**PLANNING & DESIGN COMMISSION  
CITY OF NORTH OLMS TED  
MEETING MINUTES OF FEBRUARY 23, 2011**

### **CMS10-36: North Olmsted Town Center Building B; 24800 Brookpark Road**

**BIO-RETENTION TYPICAL SECTION--A**

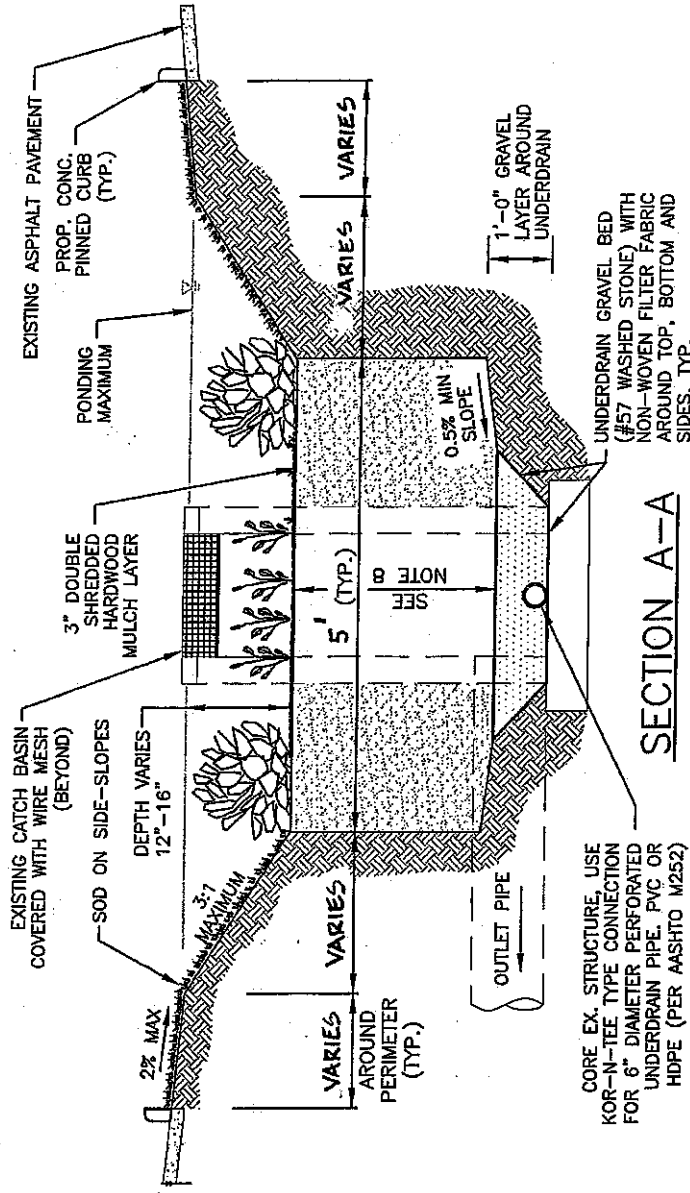
Ms. Wenger said this proposal consists of a detailed plan amendment from the previously approved plans for Building B and the site immediately around the building. At the applicant's previous appearance, the commission requested the applicant provide material samples, specify the plantings for the bioretention areas for Mr. Malone to review, and submit a master sign plan. A number of variances are required for signage. The bioretention detail was forwarded to Mr. Malone for review. Mr. Mitchell said the photometric site plan is code complaint. The light fixture specifications and cut sheets have been submitted and approved. A preliminary review of signage and number of variances required was completed. Mr. DiFranco said the preliminary bioretention drawing shows water ponding for 12-16" of depth. The ODNR allows 6-9" of depth maximum. That may increase the required area of bioretention and should be considered when preparing the final design.

Mr. Rerko said his requested changes have been made. On the elevation drawings the areas for signage have been boxed out. It was stated if those areas were not used for signage the applicants would submit a minor change to replace sign areas with windows systems. Mr. Malone said there may be confusion on the definition of bioretention cells. They are not swales or wetland-like, but are specially constructed landscape features that act as a mechanism for storm water filtration through the soil. They do not require specialized types of plants. Also, the specification for soil media submitted is not acceptable. He will provide a generic bioretention soil specification to work into the plan along with his notes. He wants to see a final bioretention plan for approval, including a list of specific plants to be utilized and where they will be placed.

- 1. Final planting list and bioretention cell design approval by Mr. Malone including soil specification that meets ODNR depth requirement.**
- 2. Submittal and approval of one sign package for both tenants within 30 days from date of Building Department permit application.**
- 3. If an area designated for a sign is not used for a sign, the area will be turned back into a window system.**
